FINAL
Coal Ash Impoundment -
Specific Site Assessment Report
Arizona Public Service
Four Corners Power Plant

September 2009
Project 091330

This report presents the results of a specific site assessment of the dam safety of Lined Ash Impoundment (LAI) embankment dam and Lined Decant Water Impoundment (LDWI) embankment dam at the Four Corners Power Plant in Fruitland, New Mexico. This assessment was performed on May 19th and 20th of 2009.

VIBRATING WIRE PIEZOMETER CLUSTER & SETTLING PLATE LOCATIONS
1"=200'
CONTOUR INTERVAL=2'

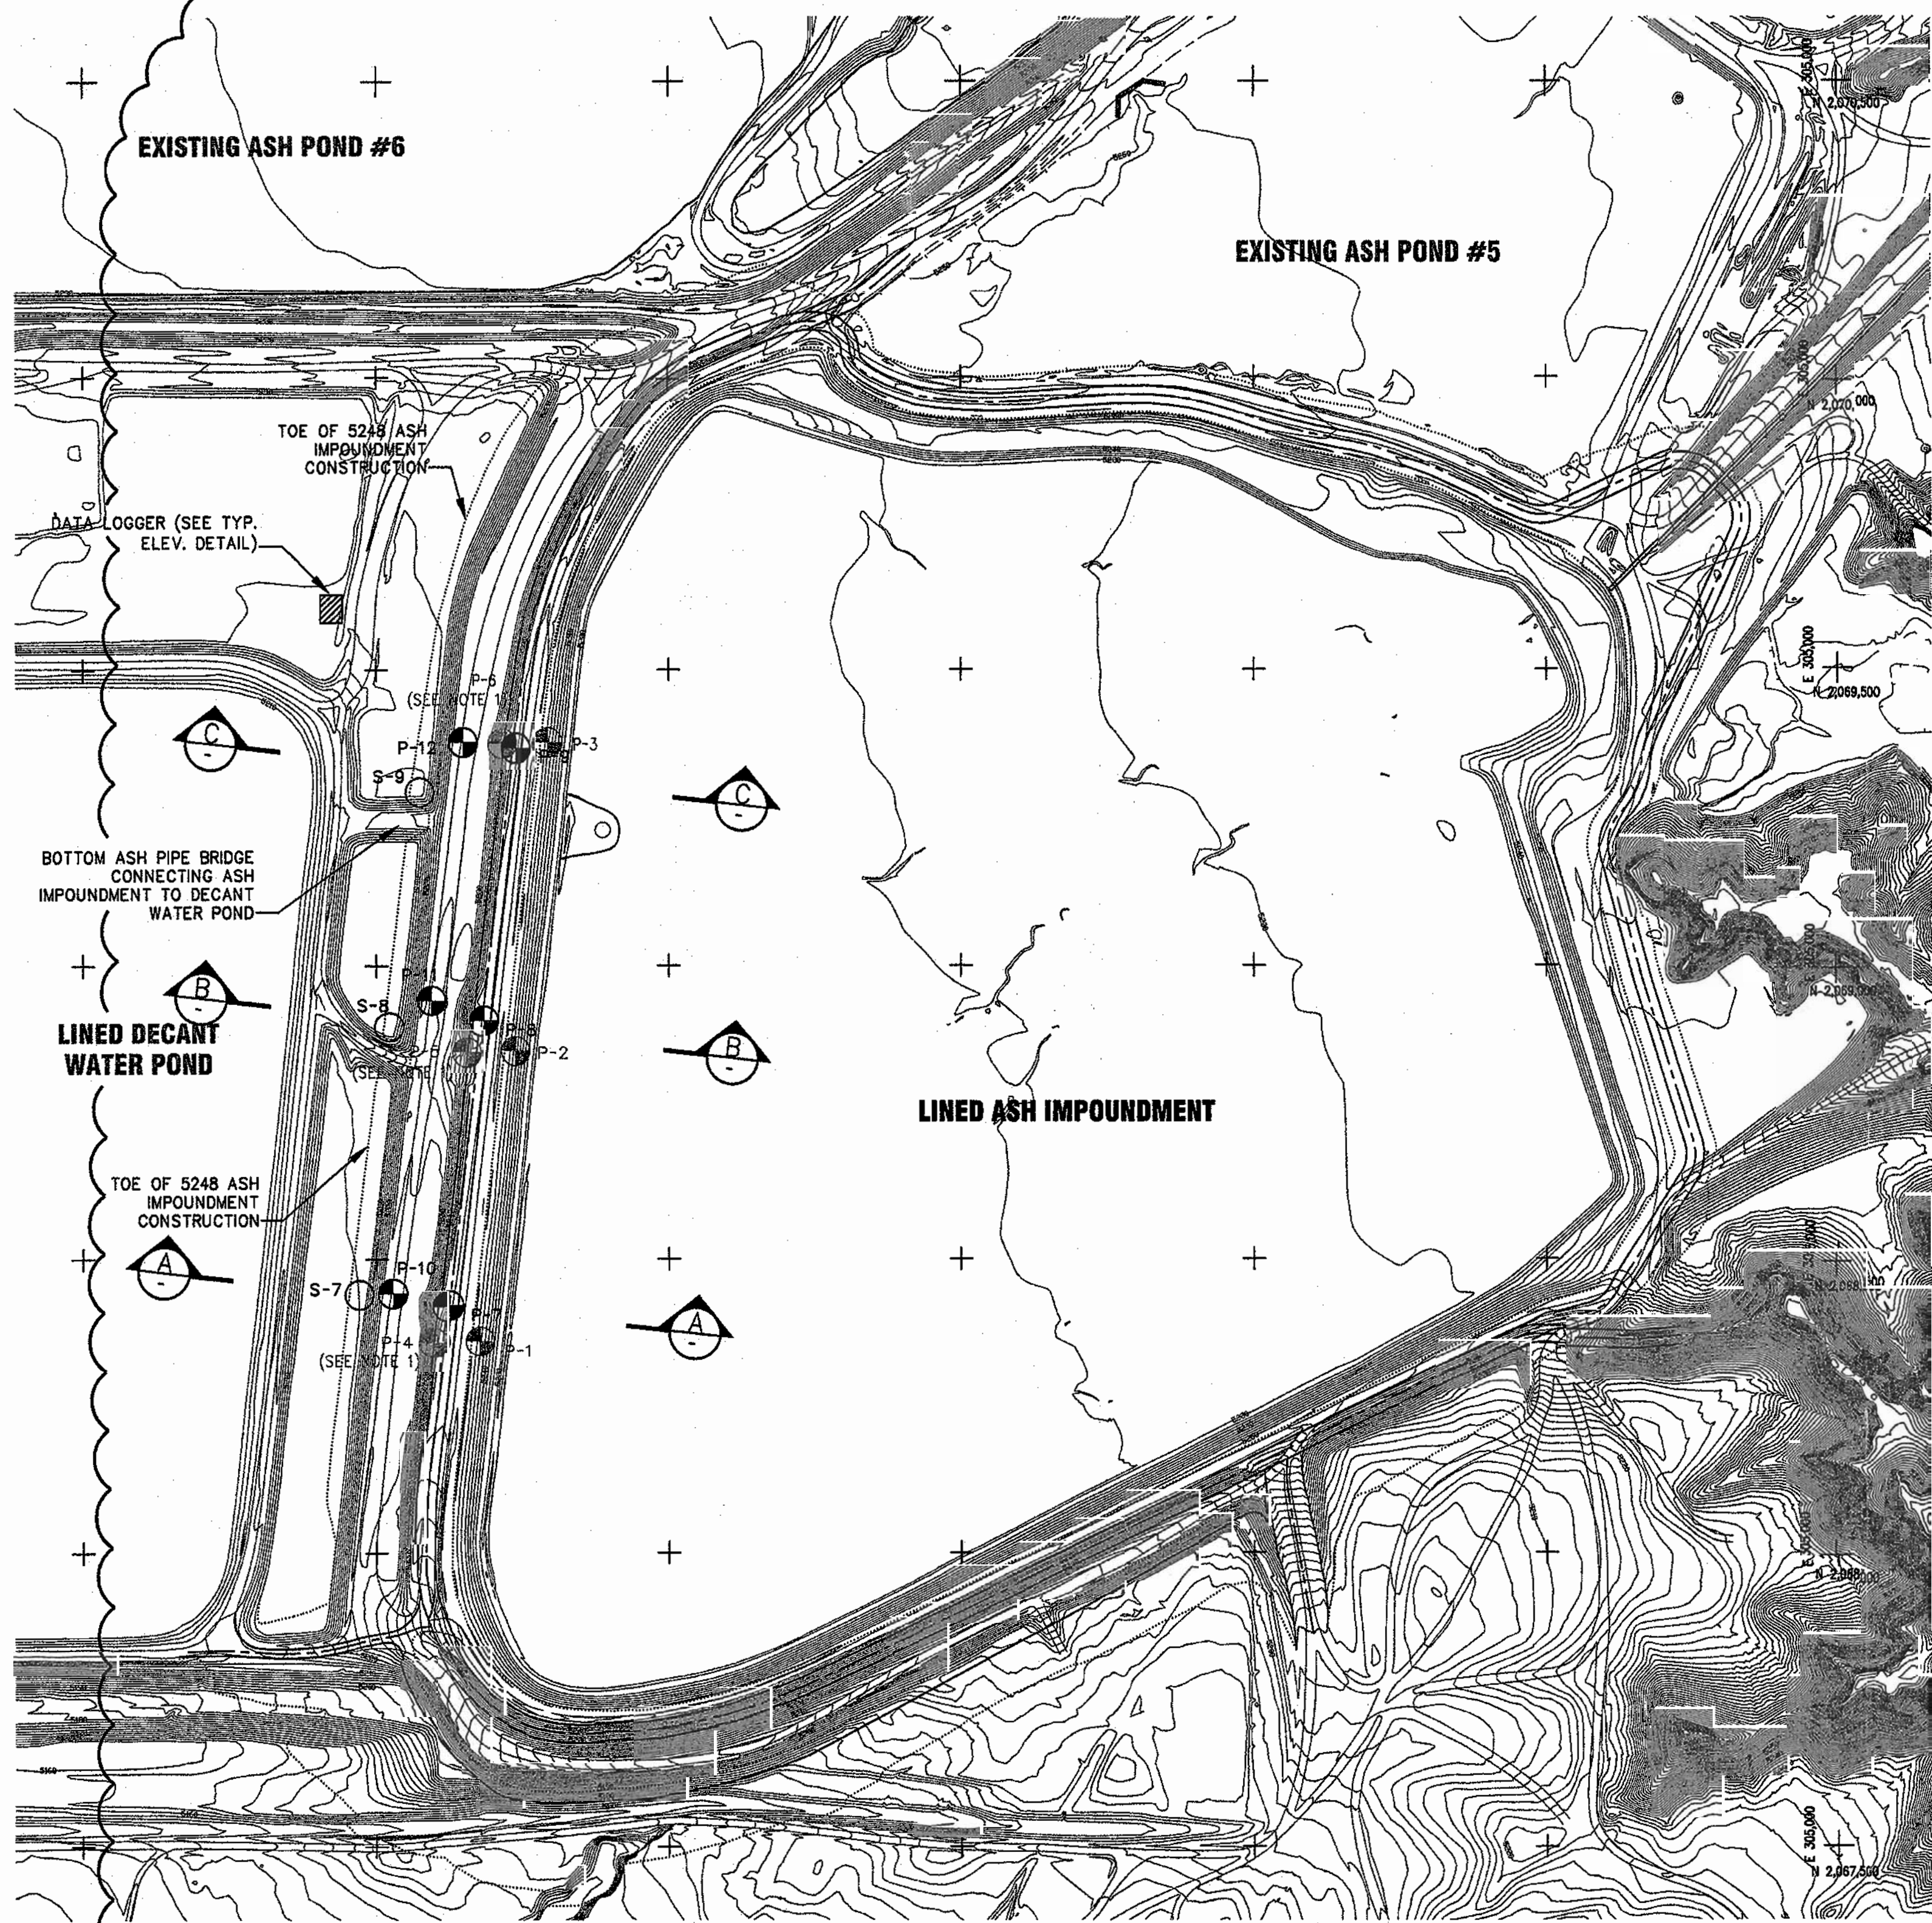
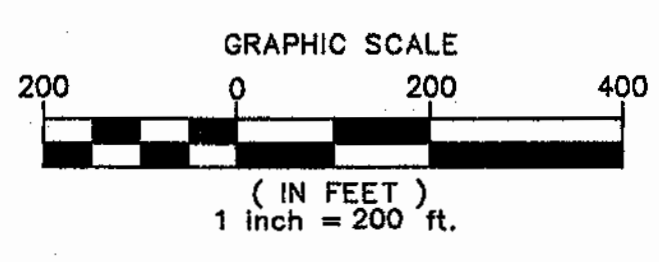
The frequency of monitoring is considered adequate. Instrumentation and monitoring programs are satisfactory except that special attention should be made to monitoring potential seepage under the dam at the northwest corner of the LAI and some of the settlement plates located in the west embankment of the LAI are not currently providing useful data. The northwest corner of the LAI is the area where the LAI embankment was not tied-in to the underlying Pond 3-4 embankment to provide continuity of seepage control. A deeper trench was installed and backfilled with clay. However, this cutoff trench location presents a potential seepage pathway should the HDPE lining fail. A potential seepage pathway would

Expand program to include additional monitoring of potential seepage under the dam at the northwest corner of the LAI, where the LAI embankment was not tied-in to the underlying Pond 3-4 embankment to provide continuity of seepage control, and where a potential seepage pathway exists if the HDPE lining fails. Install additional piezometers to address this potential seepage pathway and expand documentation in APS dam safety inspections to note any evidence of seepage near the downstream toe of the dam in this area.

Repair or replace the two settlement plates that do not appear to be providing useful information and that may have been damaged during construction or maintenance activities.
